ARCHITECT'S ADDENDUM No. 003

Project: PFISD Campus Modernization – Phase 3
RA# 2407.1
Owner: Michael Porter
2021Crystal Bend Dr
Pflugerville, TX 78660
Architect: Reliance Architecture, LLC
12 Chisholm Trail, Suite 200
Round Rock, TX 78681

Date of Issuance: January 31, 2025

Addendum to the Drawings and Project Manual dated January 17, 2025.

ROWE LANE DEMO FLOOR PLAN A2.00

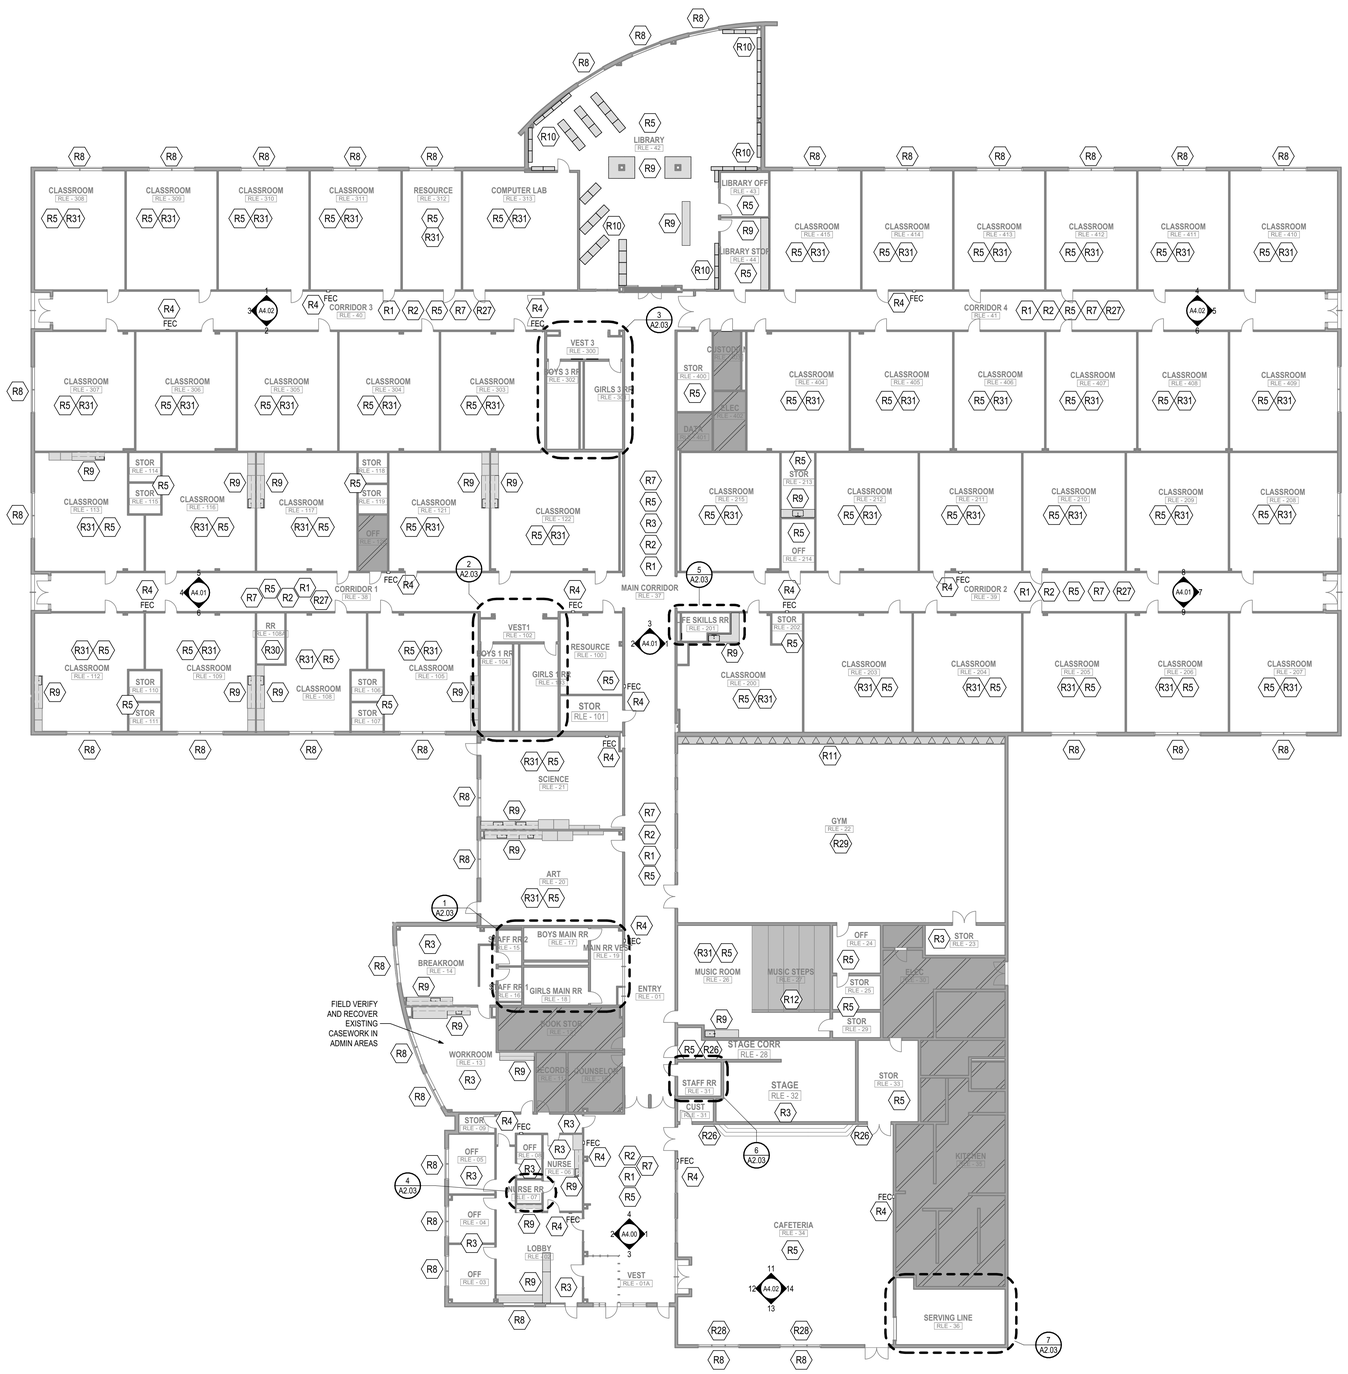
1. Sheet A2.00 Keynote 19 is shown at Music Steps RLE 27 but there is no corresponding information to D19. Please provide information.
    A. ADDRESSED IN ADDENDUM 003. D19 STATES TO PREP EXISTING HANDRAILS FOR NEW PAINT.

Item 2. Sheet A2.00

A. Added demo note to admin areas.
B. Cleaned up notes that were blocking information.
C. Added demo notes to gym.
D. Demo handrails at stage.
E. Add demo notes to stage.
F. Updated demo key notes.

Sheet Number
DESSAU DEMO FLOOR PLAN A2.04

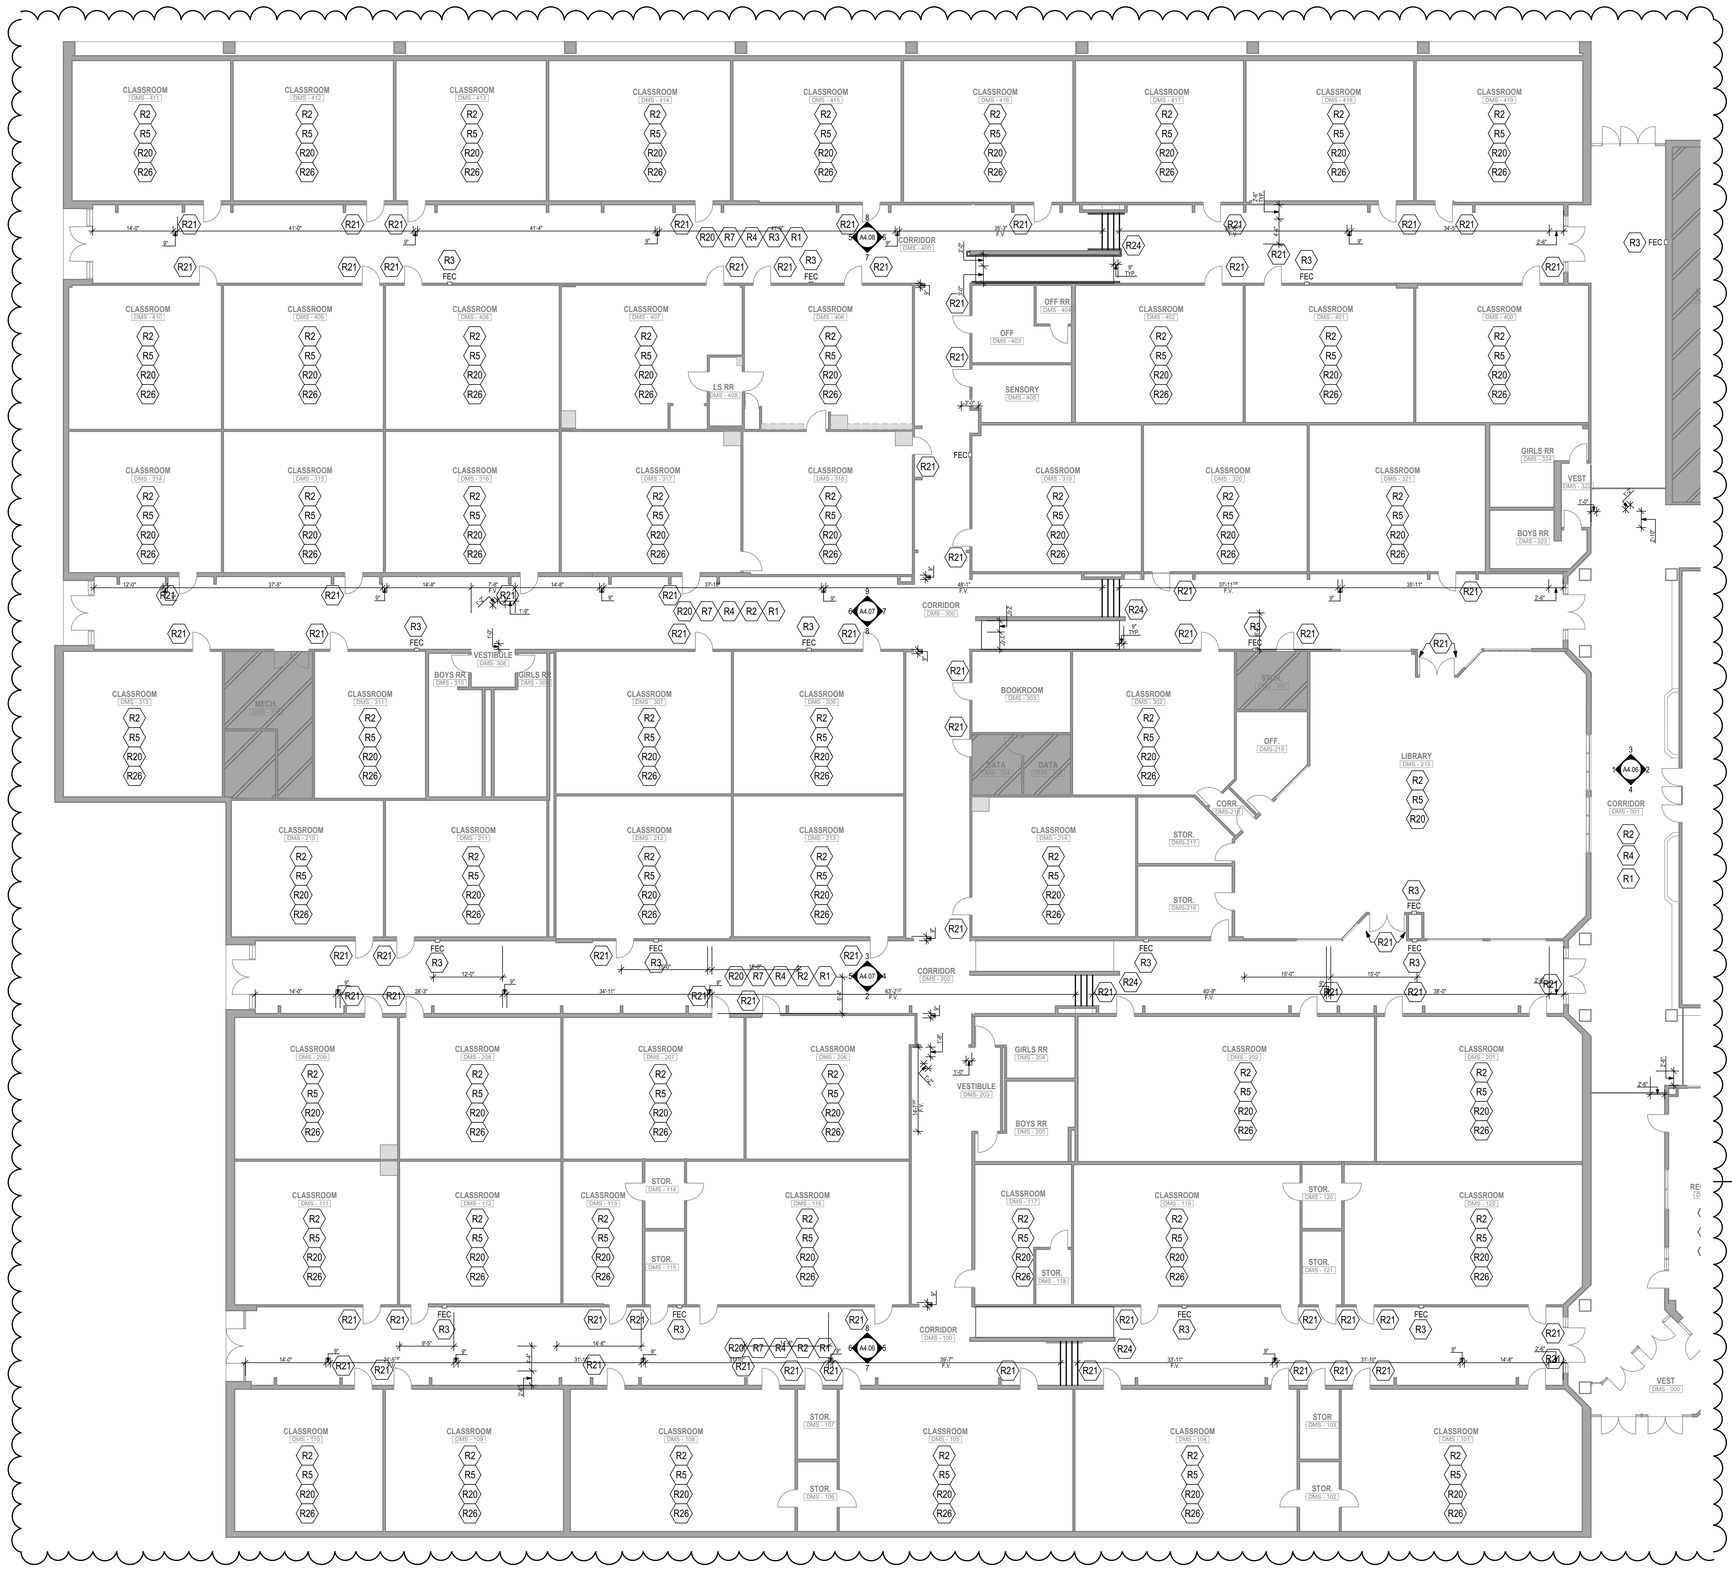
1. A2.04 keynote D24 is shown on plan but there is no corresponding D24 note in the legend. Provide D24 keynote
    A. ADDRESSED IN ADDENDUM 003. D24 STATES TO DEMO ALL EX-SIGNAGE, SOAP DISPENSERS, TACKBOARDS, DOOR STOPS, AND ANY OTHER MISCELLANEOUS FIXTURES.

FLOOR FINISH PLAN ROWE LANE A8.00

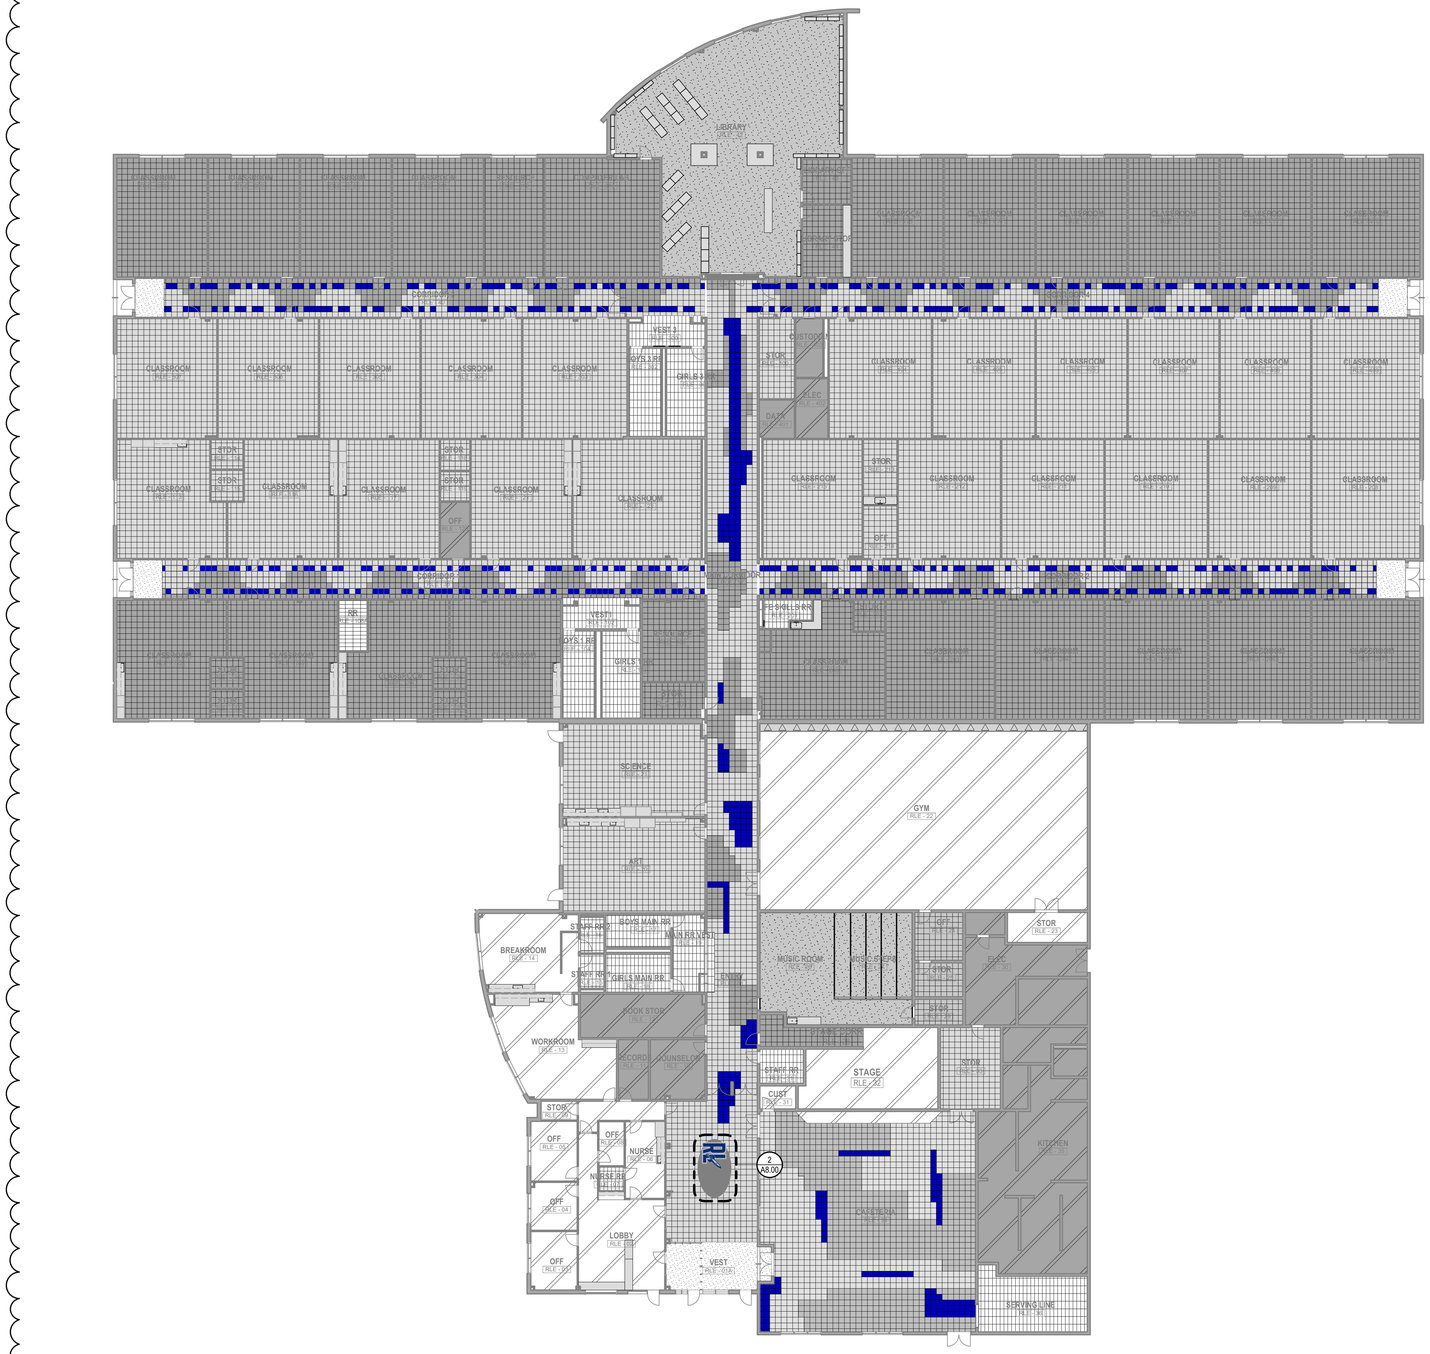
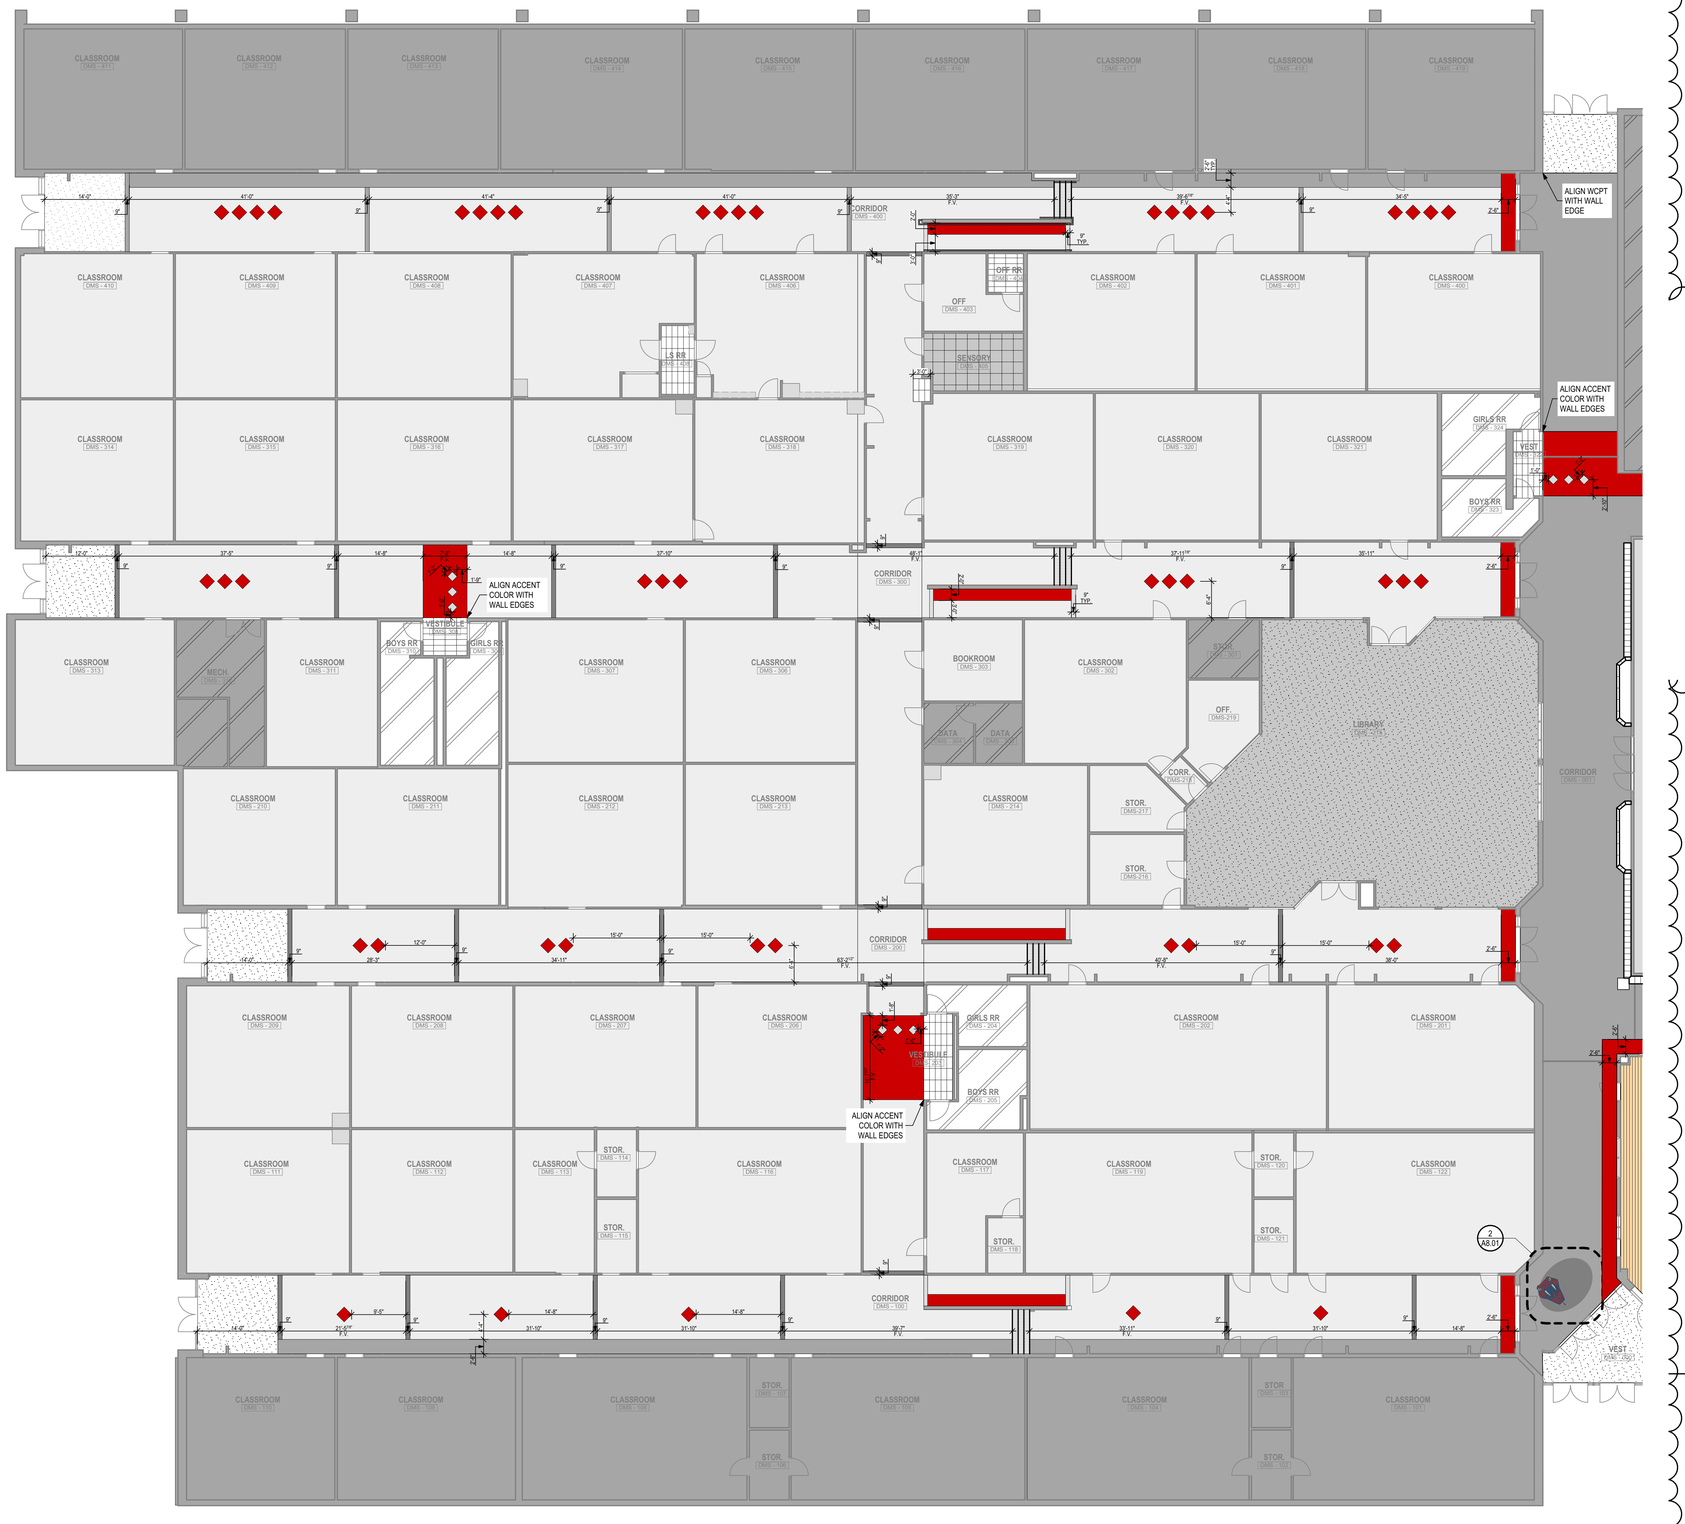
6. A8.00 legend shows vestibule to have CPT. Finish schedule calls for WCPT at vestibule. Confirm CPT or WCPT.
    A. ADDRESSED IN ADDENDUM 003. VESTIBULE TO HAVE WCPT (WALK OFF CARPET)

12. A8.00 Rooms 113-122 show to be LVT 1. Finish schedule calls for these rooms to be LVT2. Confirm which is correct.
    A. ADDRESSED IN ADDENDUM 003. ROOMS 113-119 AND 121-122 ARE TO BE LVT1. ROOM 120 IS NOT IN SCOPE.

A. Updated line weight.
B. Updates legend.
C. Updated custodial flooring.
D. Various cleanup of items that do not relate to finish floor plan.
E. Updated RR in room 108 to have tile flooring.
F. Vestibule changed from CPT to WCPT.

FLOOR FINISH PLAN DESSAU A8.01

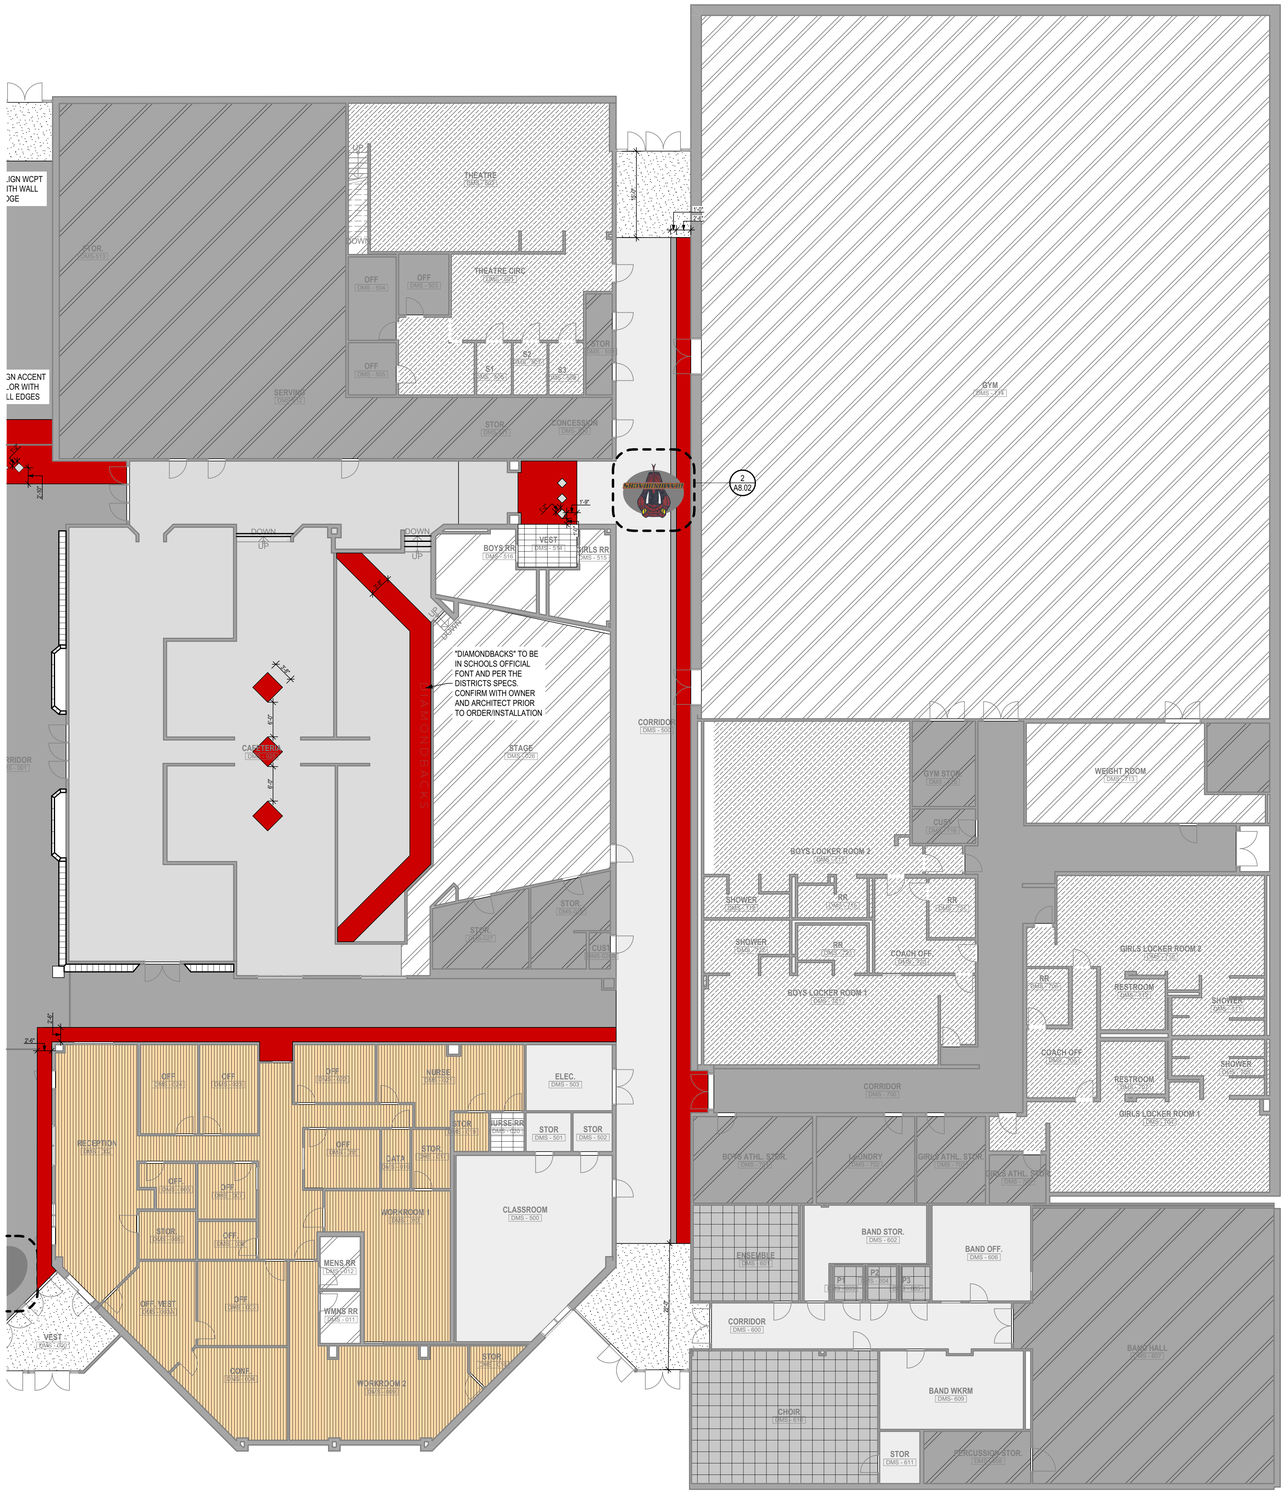
A. Updated Finish floor legend.
B. Added dimensions for floor pattern.
C. Corrected line weights.
